# EAST TOWN CROSSING FRONTAGE IMPROVEMENTS

## COVER SHEET

# EAST TOWN CROSSING SHAW ROAD IMPROVEMENTS

EAST TOWN CROSSING PIONEER WAY IMPROVEMENTS  
SEC. 26,35/ TWP. 20 N./ RGE. 4 E., W.M.

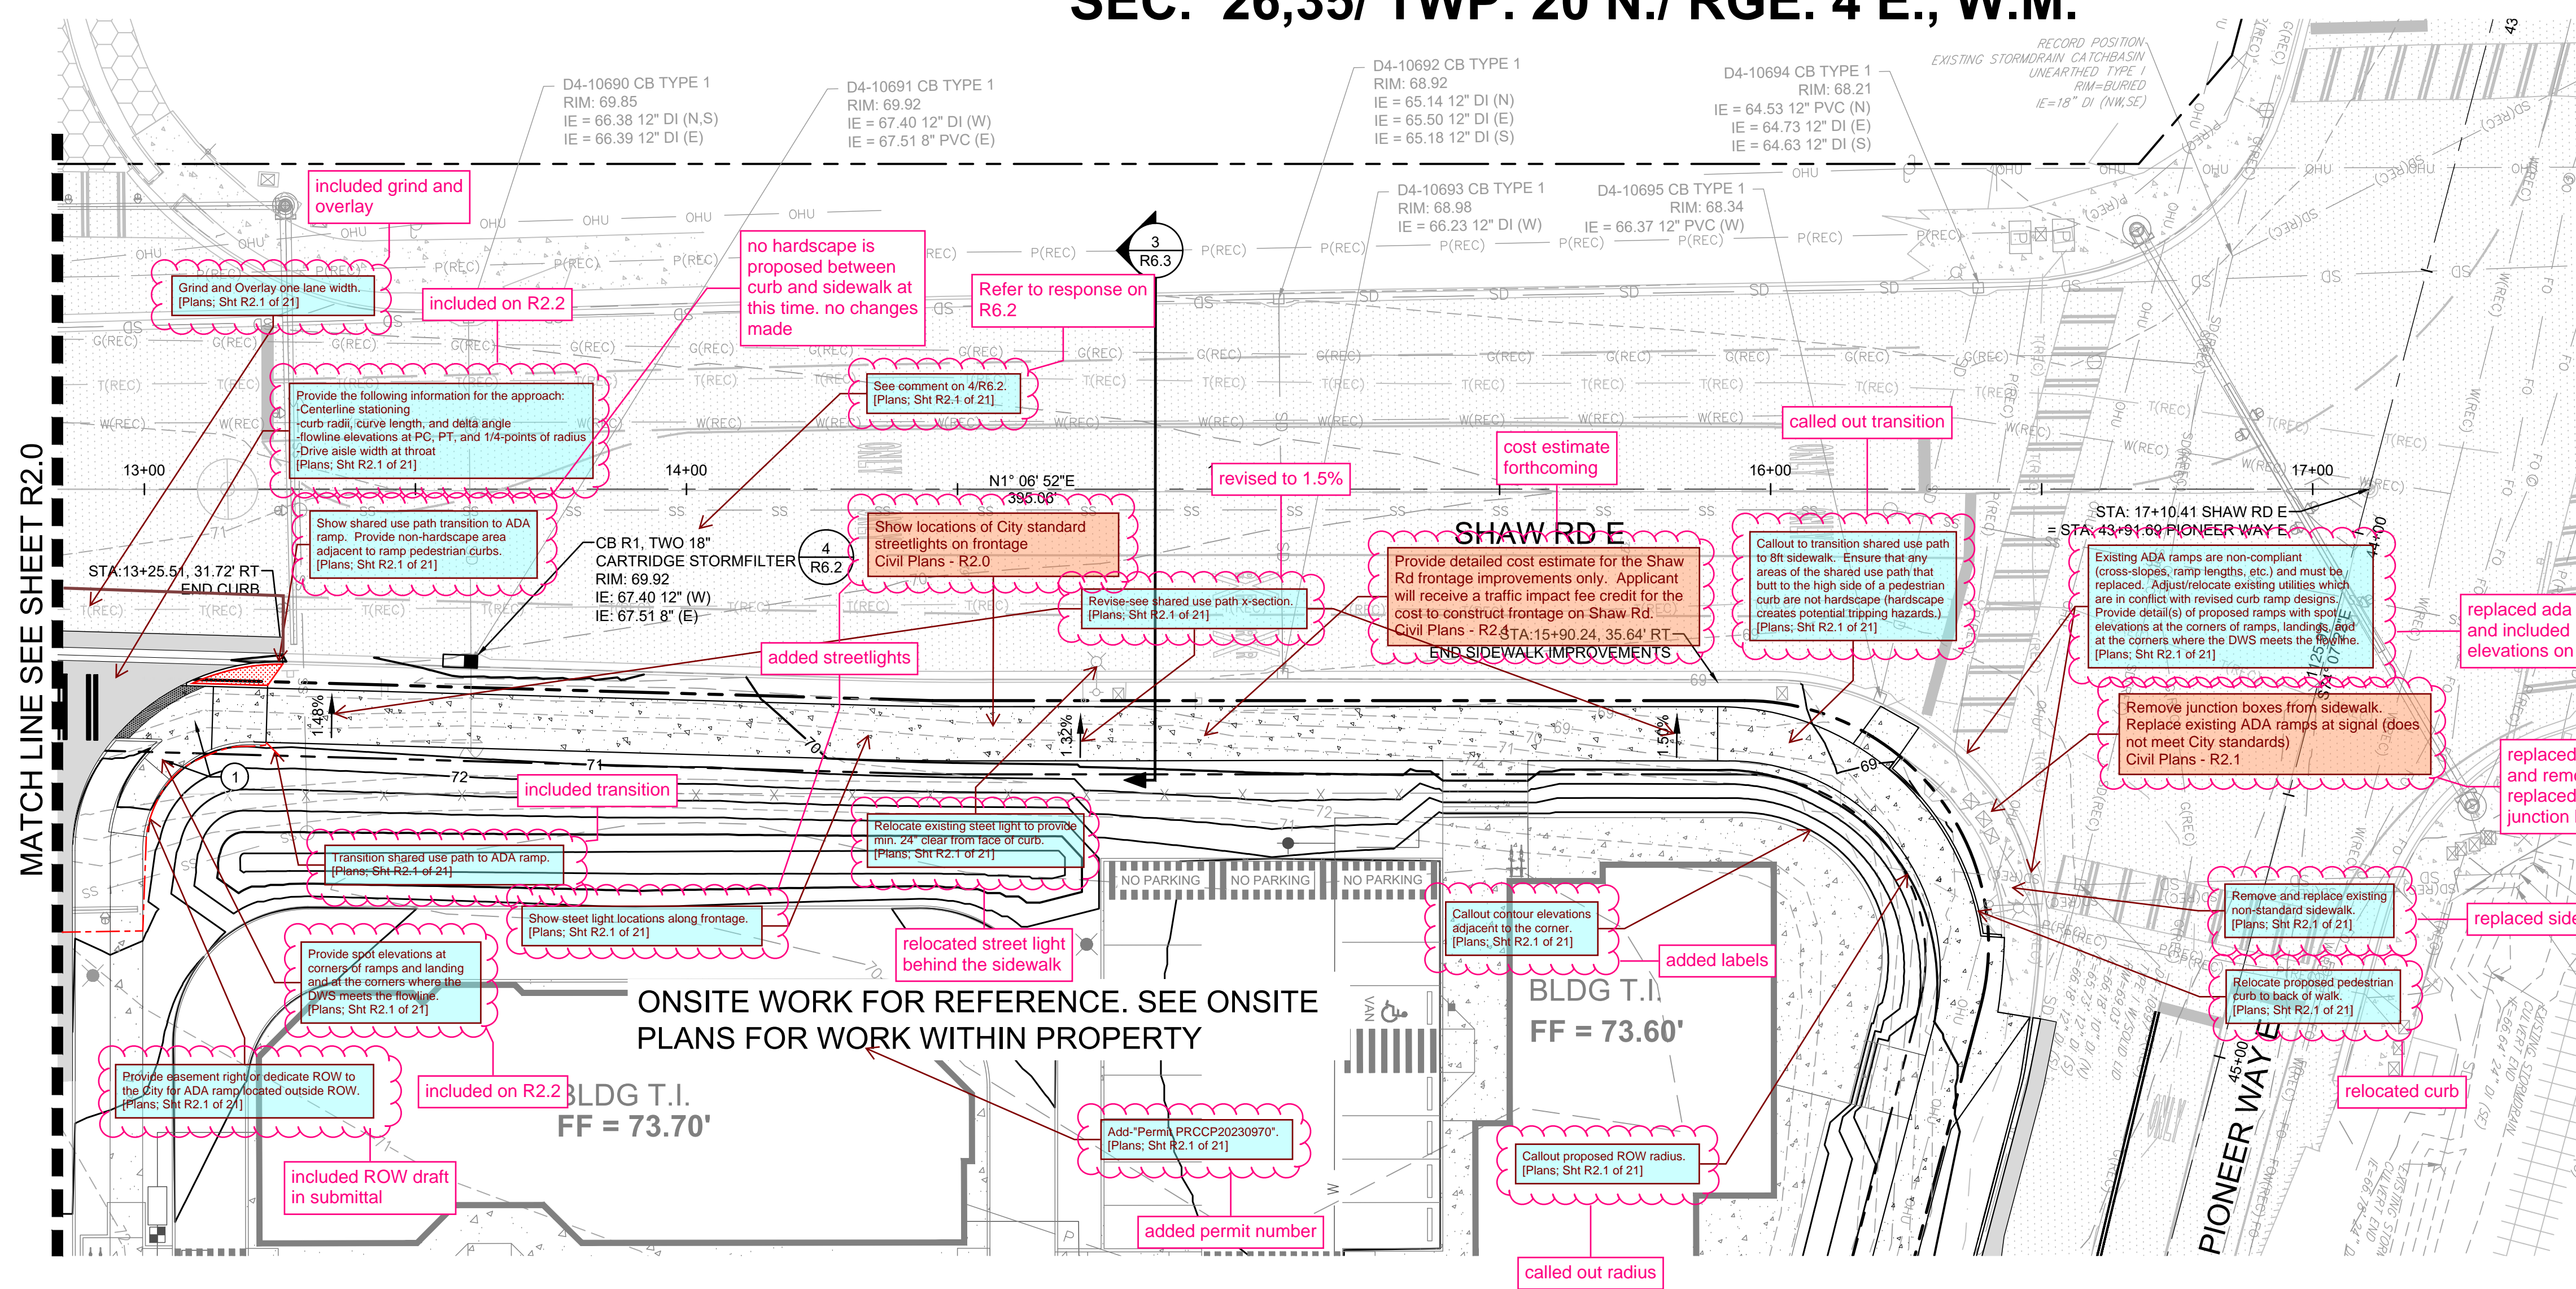
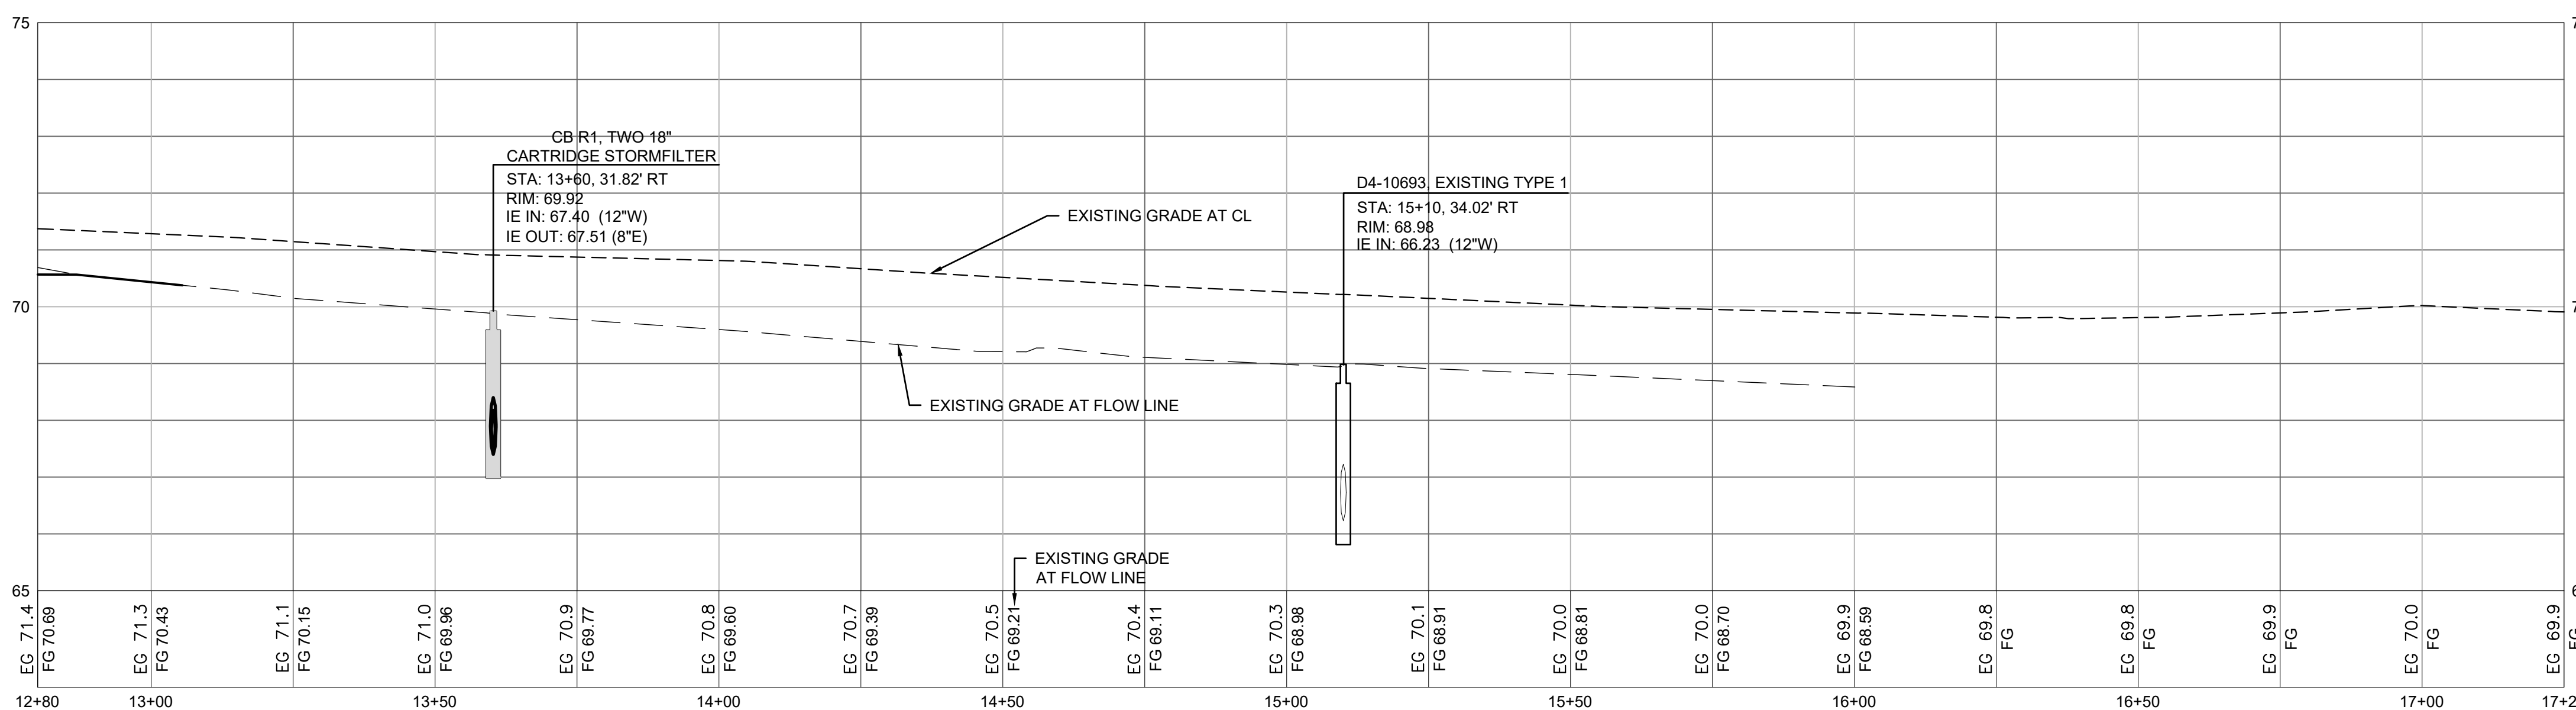
Add note that shared use path to be pervious pavement per details on Sheets R6.3 and R6.5, but ADA ramps to be conventional concrete pavement. [Plans: Sht R2.1 of 21]

Sheet No.  
**R3.0**  
6 of 21 Sheets

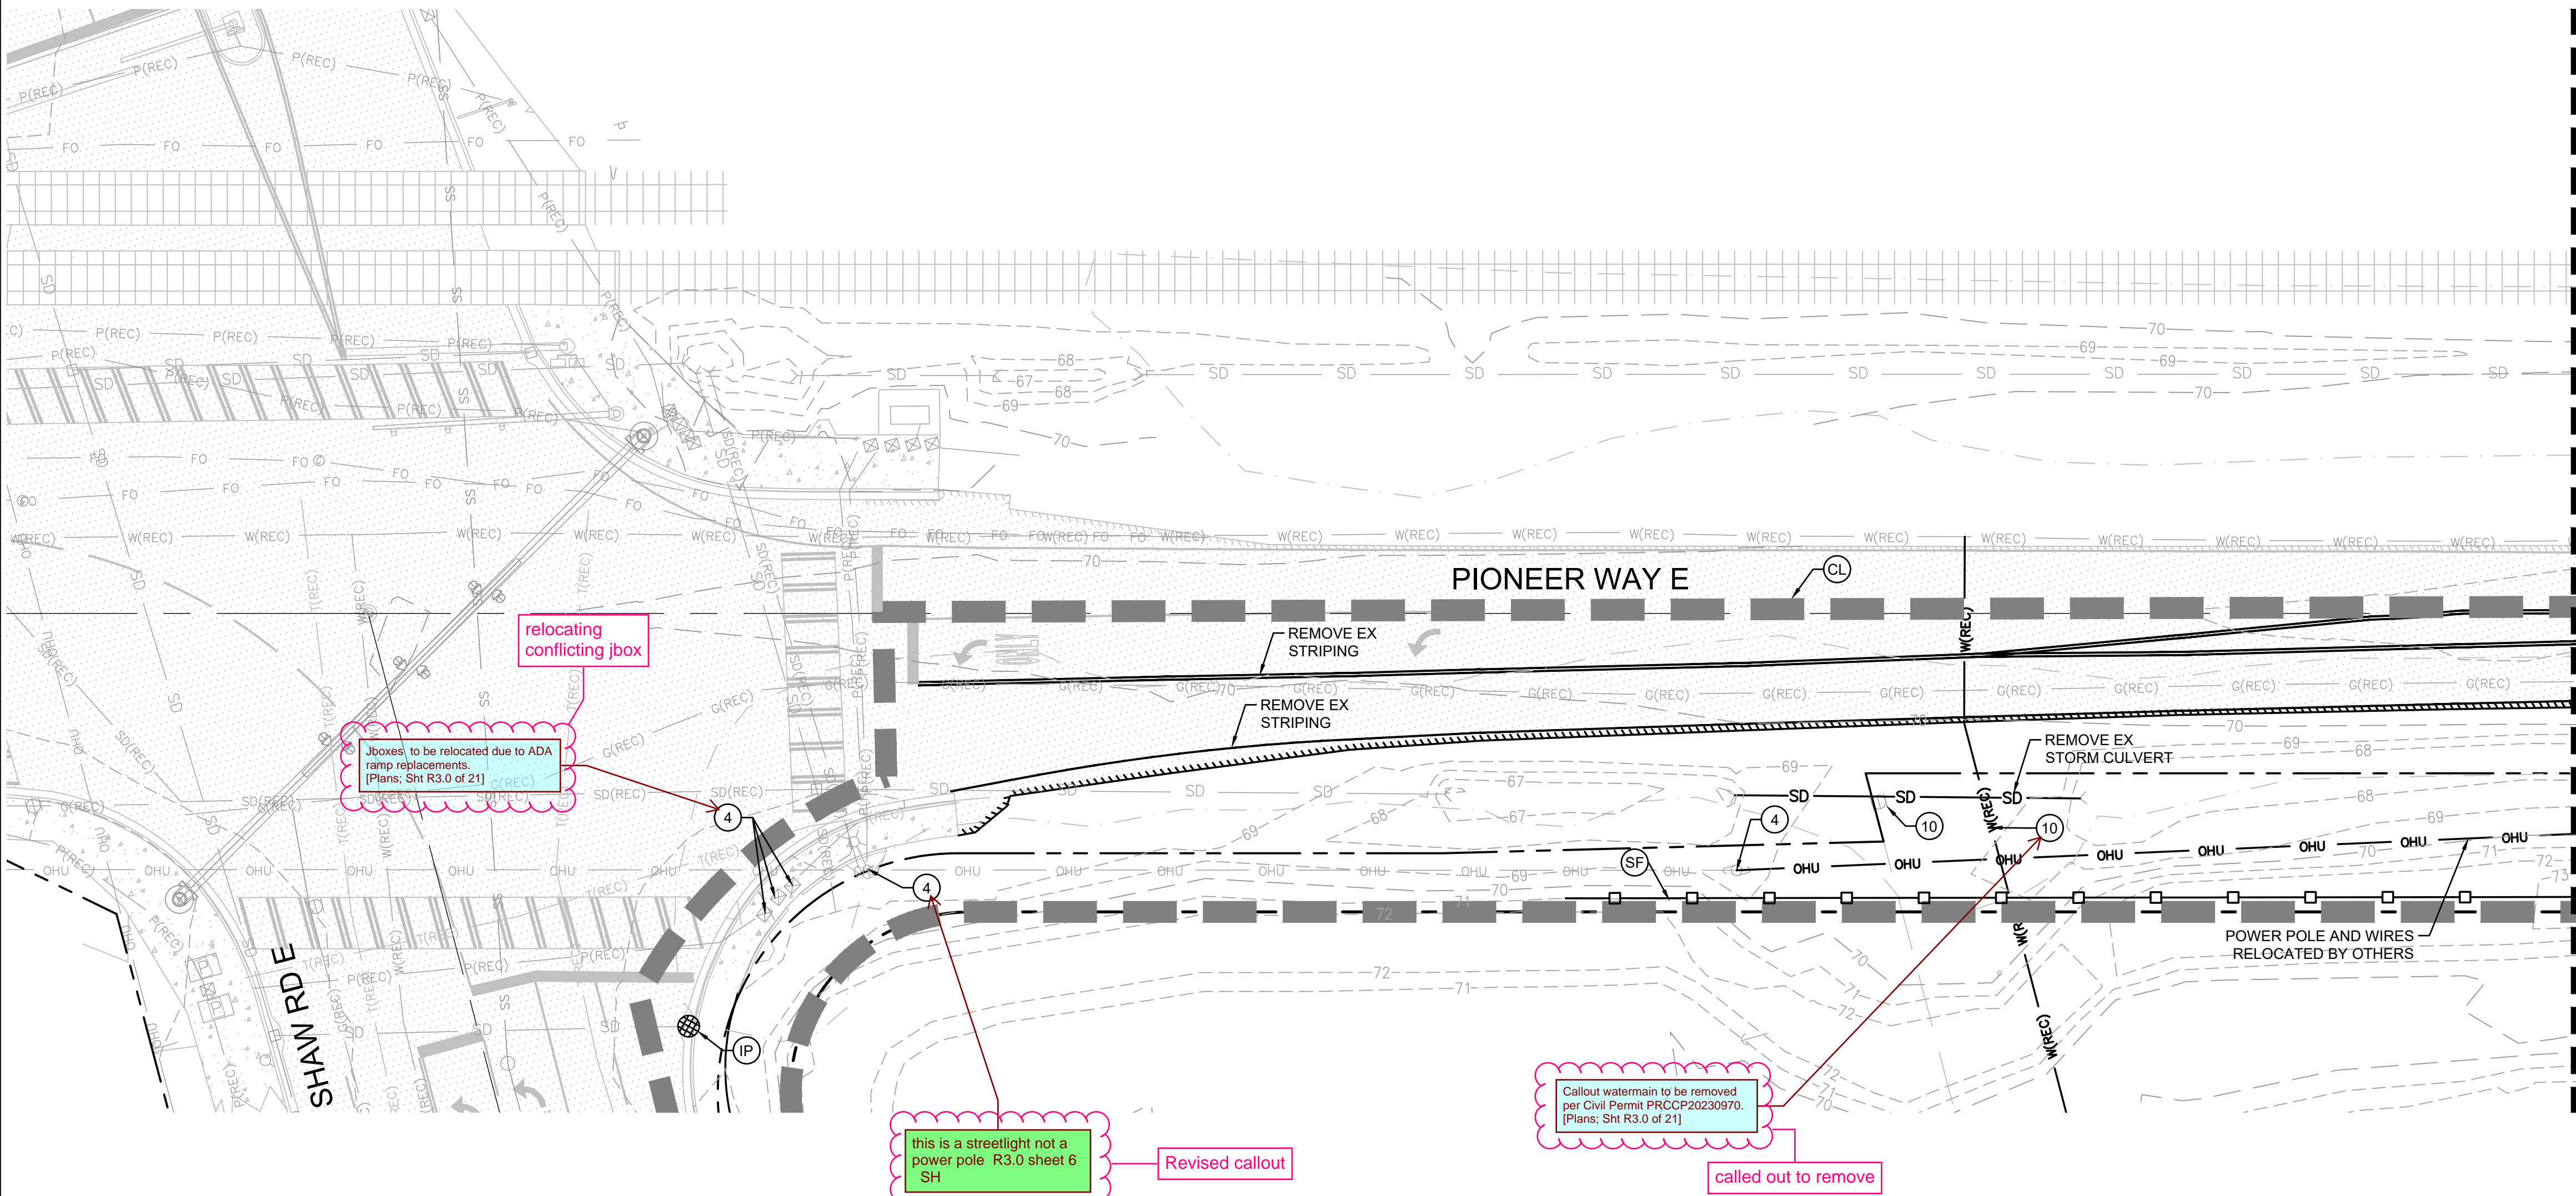
Add the following notes to the planset:  
-Existing public utilities that are in conflict with proposed frontage improvements shall be relocated as necessary to meet all applicable City, State, and Federal requirements.  
-Existing private utilities (power, gas, telcom, cable, etc.) that are in conflict with City maintained right-of-way and utilities shall be relocated outside of the travelled road section, i.e., behind the curb under the sidewalk area or other location as approved by the City.  
[Plans: Sht R3.0 of 21]

Clarify-Keynote 4 is also being used for existing light standard and poles at the intersection.  
[Plans: Sht R3.0 of 21]

revised misused keynotes

**R3.1**

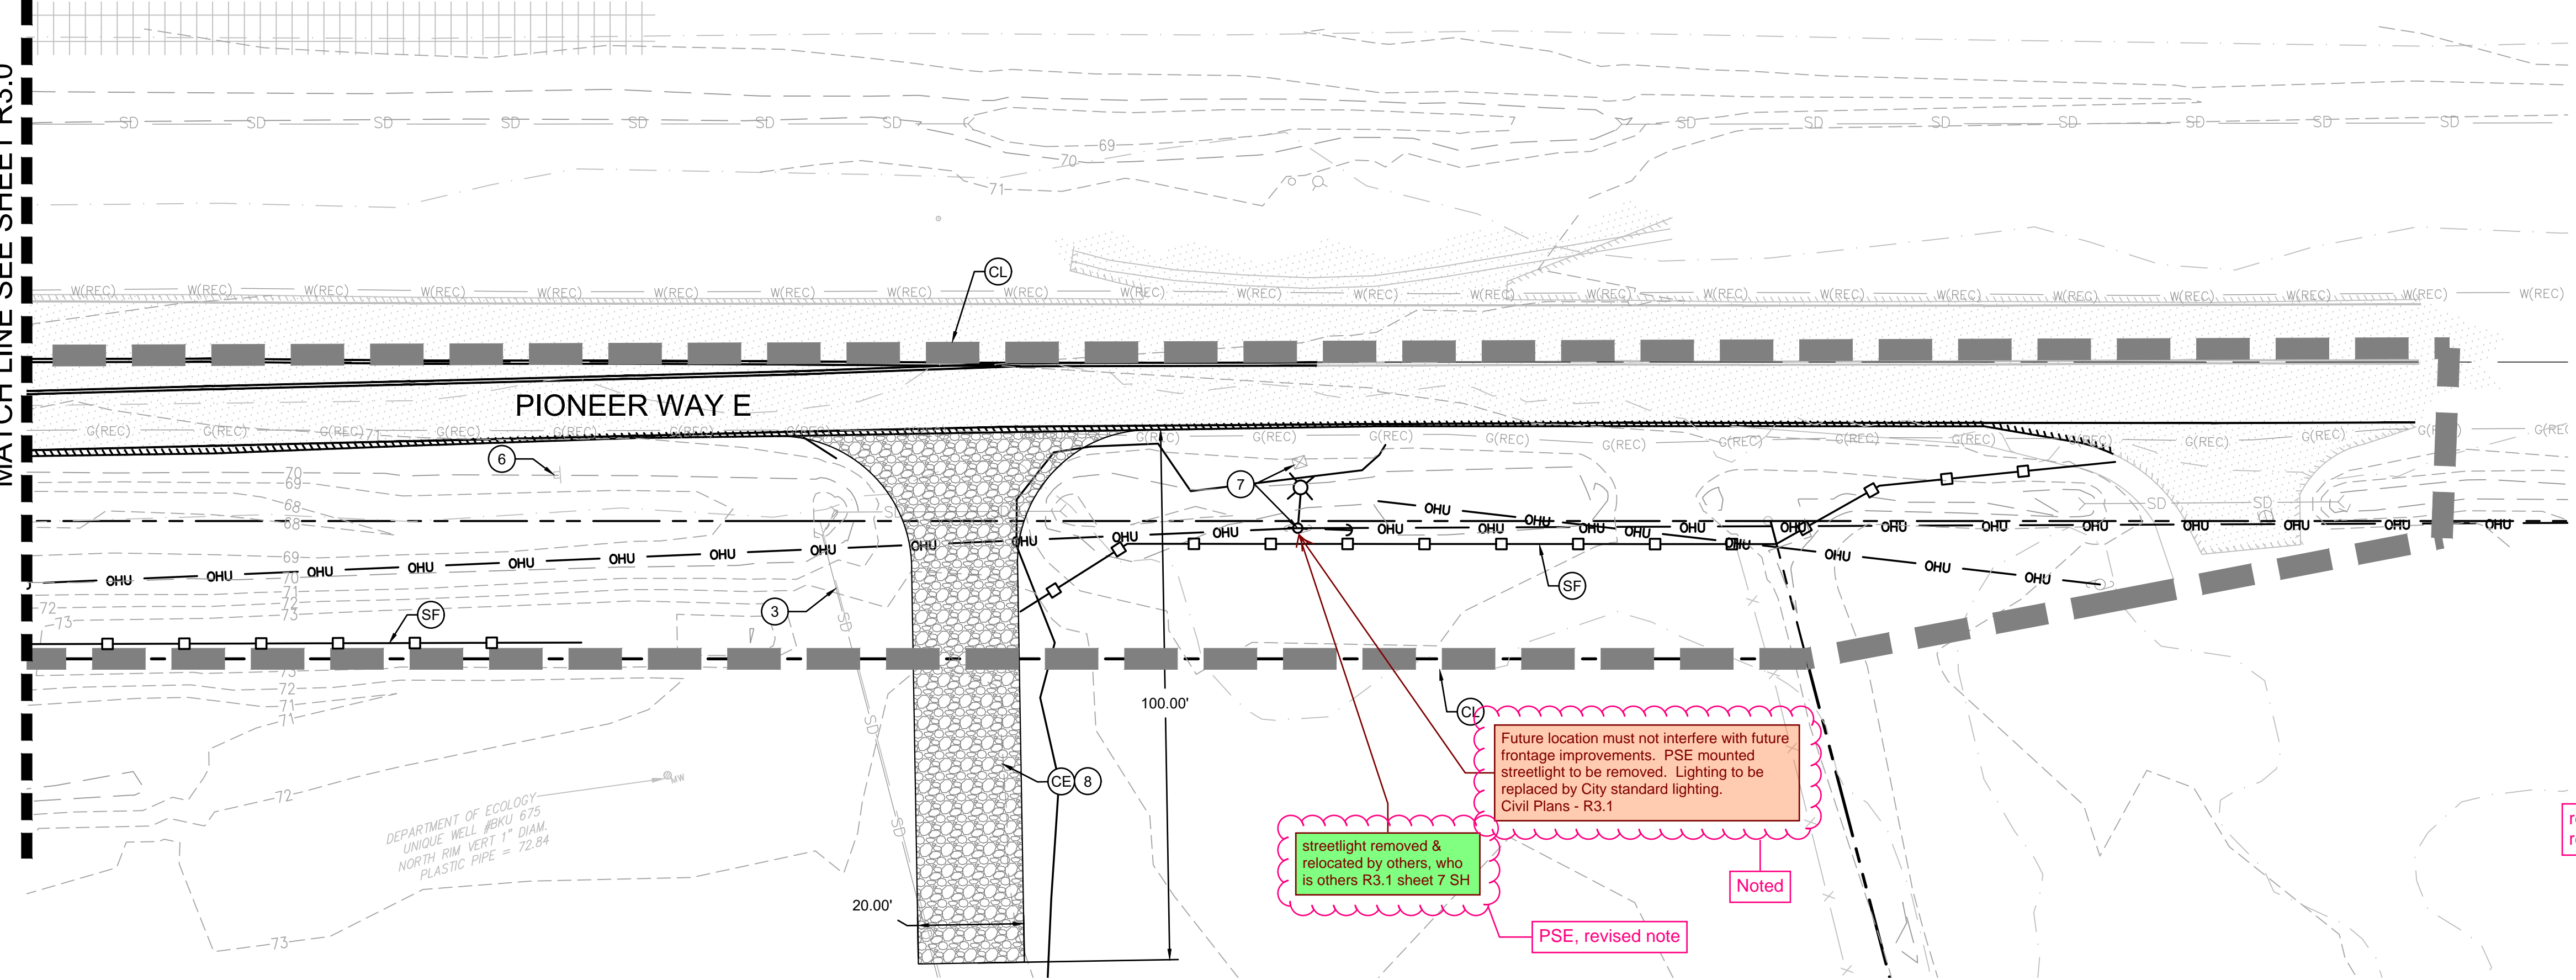
Add the following notes to the planset:  
-Existing public utilities that are in conflict with proposed frontage improvements shall be relocated as necessary to meet all applicable City, State, and Federal requirements.  
-Existing private utilities (power, gas, telecom, cable, etc.) that are in conflict with City maintained right-of way and utilities shall be relocated outside of the traveled road section, i.e., behind the curb under the sidewalk area or other location as approved by the City. [Plans: Sht R3.1 of 21]

Verify Note 4 reference. [Plans: Sht R3.1 of 21]

added as note 3 and 4
